**SUPERIOR CHARTER TOWNSHIP PLANNING COMMISSION
SUPERIOR TOWNSHIP HALL
3040 N. PROSPECT, SUPERIOR TOWNSHIP, MI 48198
AGENDA
FEBRUARY 23, 2022
7:00 p.m.**

**5347 Plymouth Road
Final Site Plan Documents
January 26, 2022**

SITE IMPROVEMENT PLANS FOR 5347 PLYMOUTH ROAD PROPOSED VETERINARY CLINIC

DRAWING: **C-3**

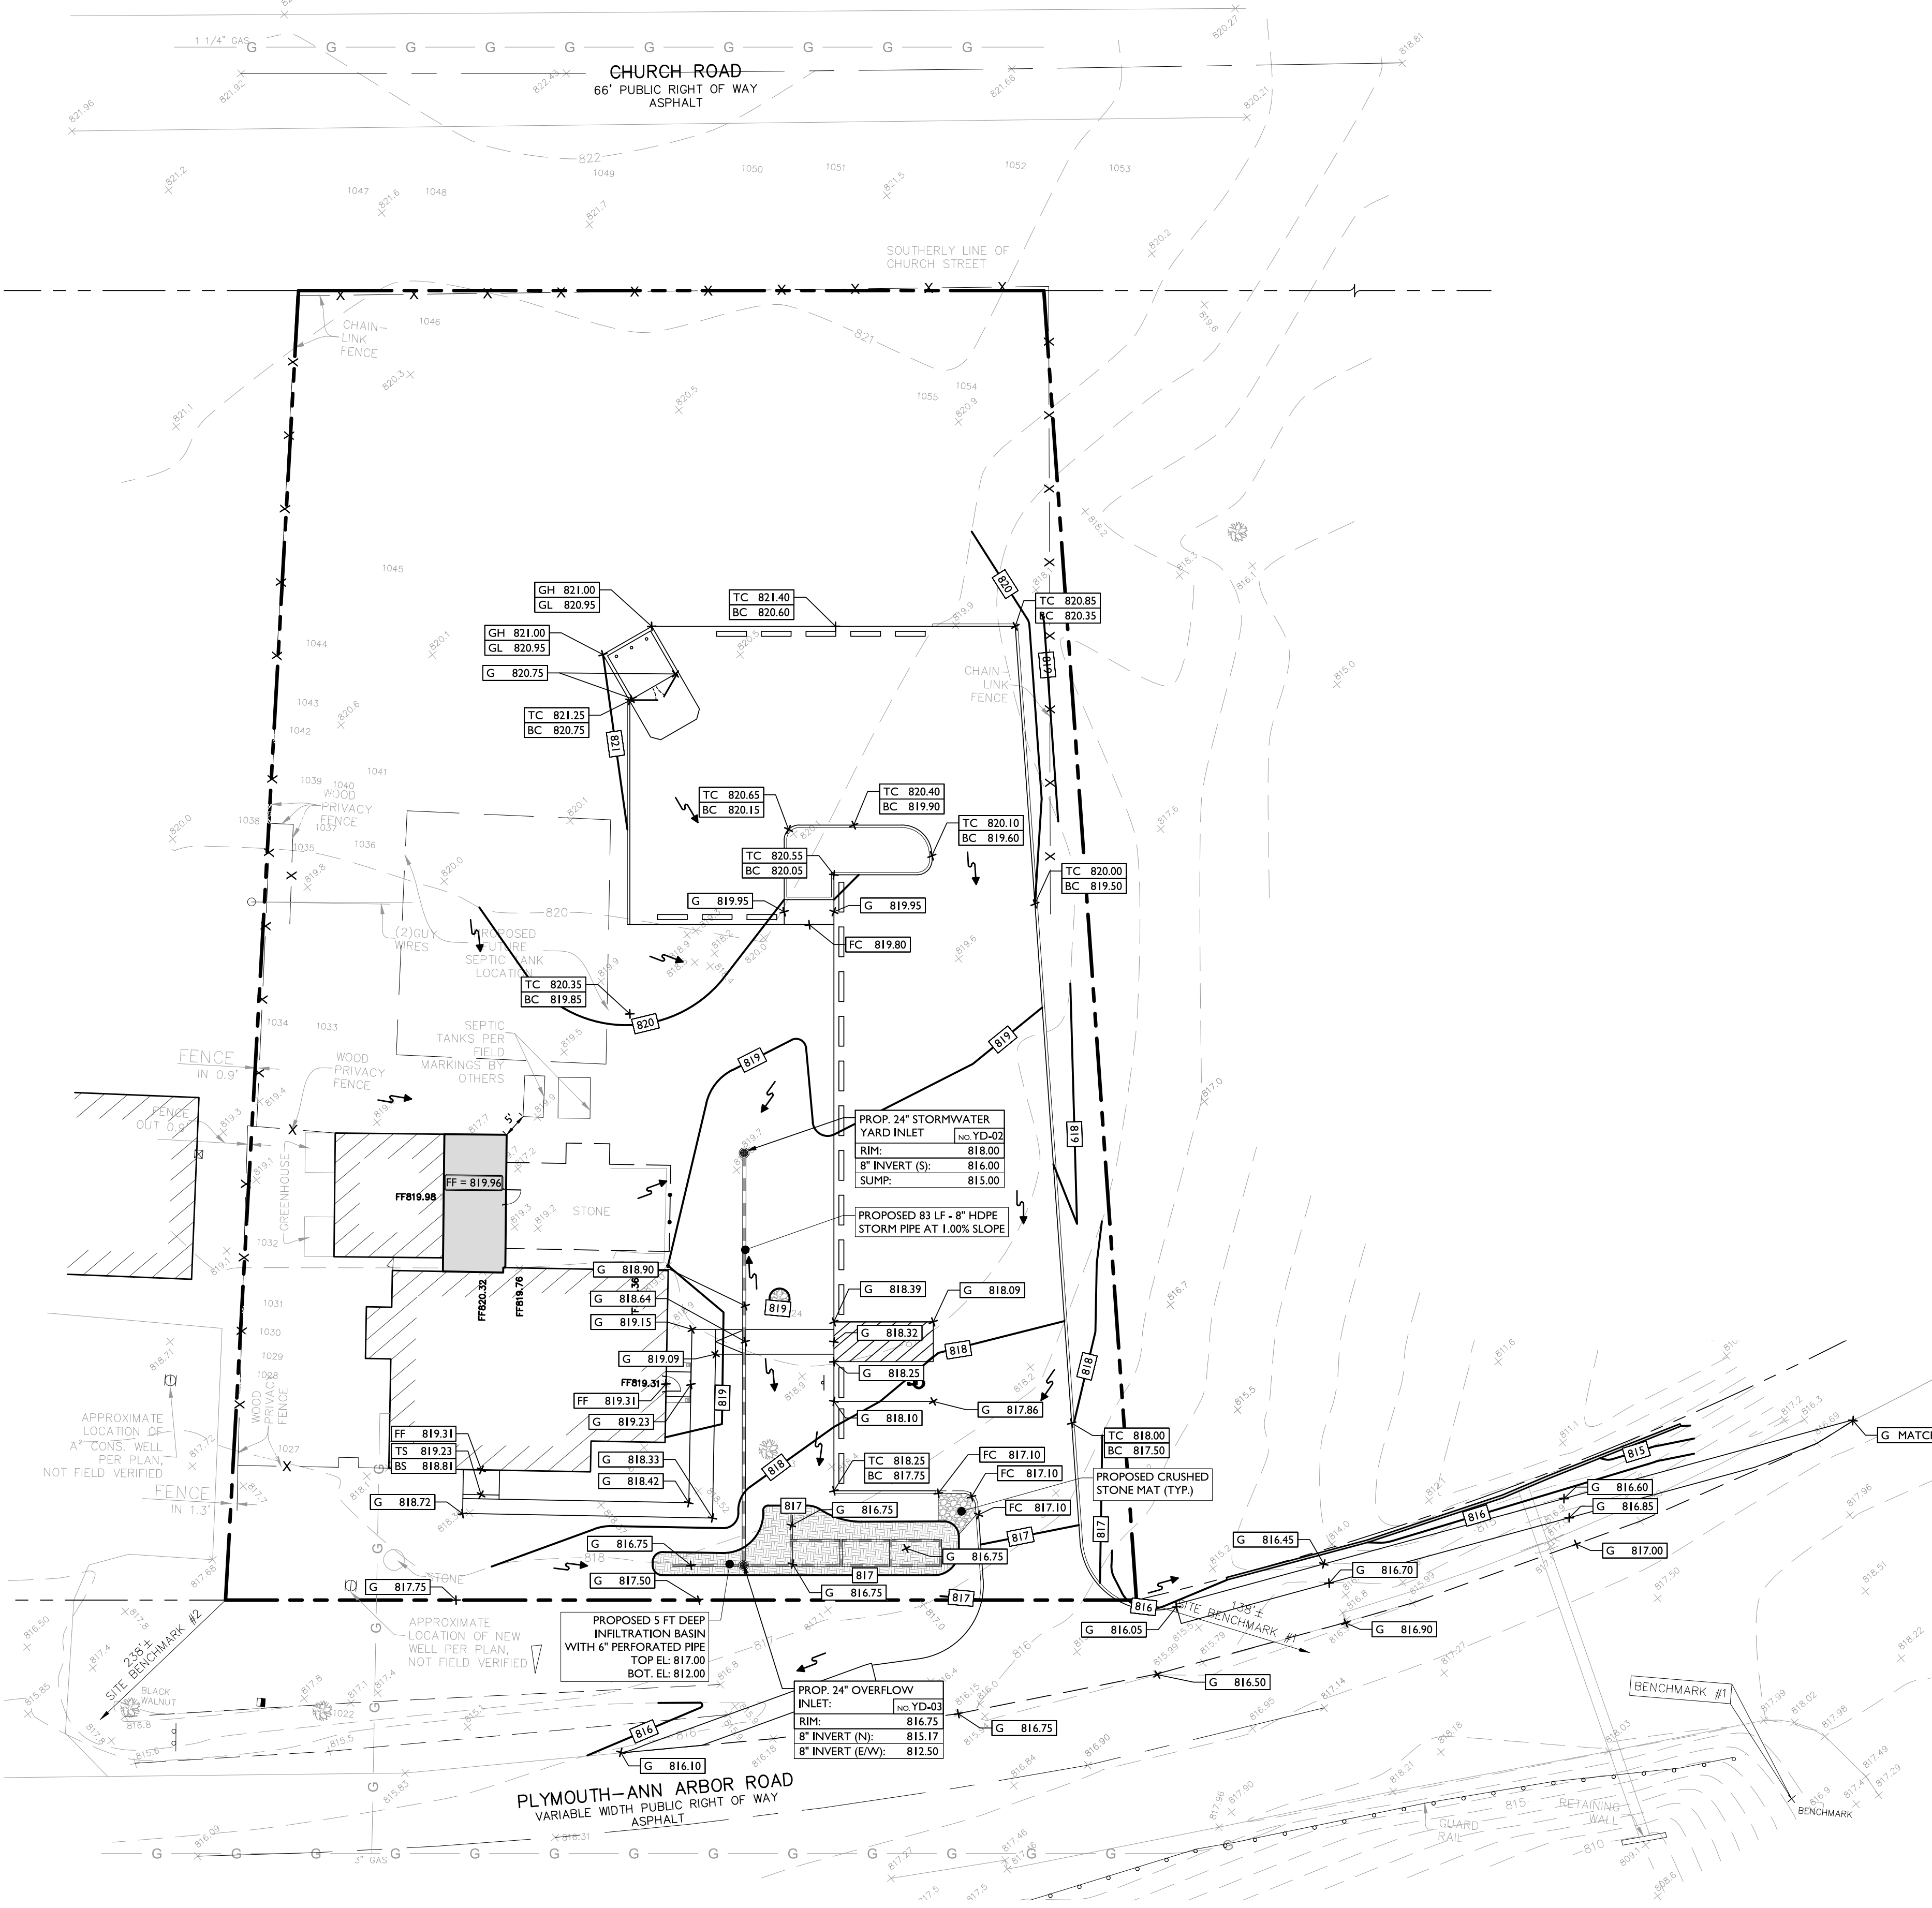
1. On Sheet C-3, *Site Plan*, the leader line from the note at the northeast corner of the parking lot (“LIMIT OF CONCRETE CURB”) should point further west to the end of the curb at the end of the striped area of the parking lot. Also, the “LIMIT ASPHALT PAVEMENT” note on the east side of the parking lot should be deleted as this side of the parking lot will have concrete curb and gutter. This should be addressed on the future engineering plan submittal.

INFILTRATION TRENCH DETAIL

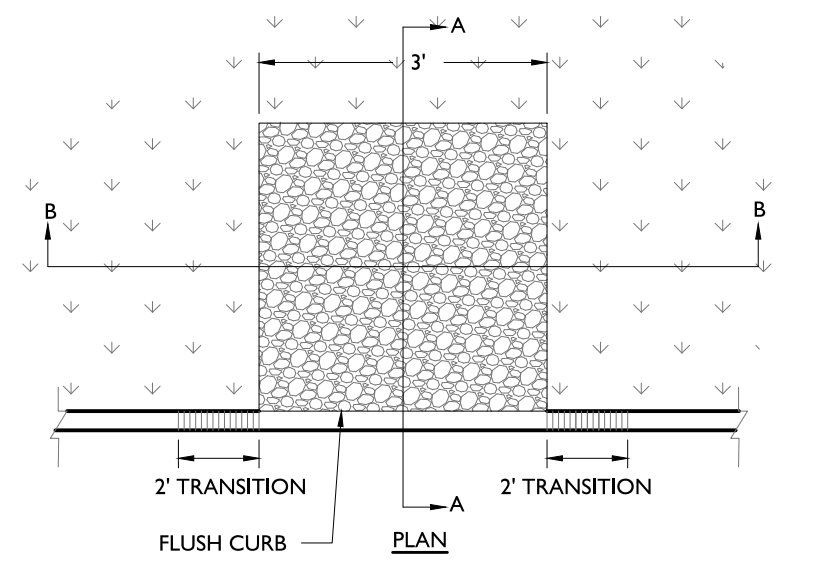
3. A detail for an infiltration trench is shown on plan sheet C-10, but no infiltration trench is identified on the site plans.
4. The crushed stone mat detail shown on plan sheet C-10 identifies the bioretention retention area as having 18 inches of amended topsoil and references a detail. No additional detail is included for the bioretention basin, and the composition of the amended topsoil is not defined.
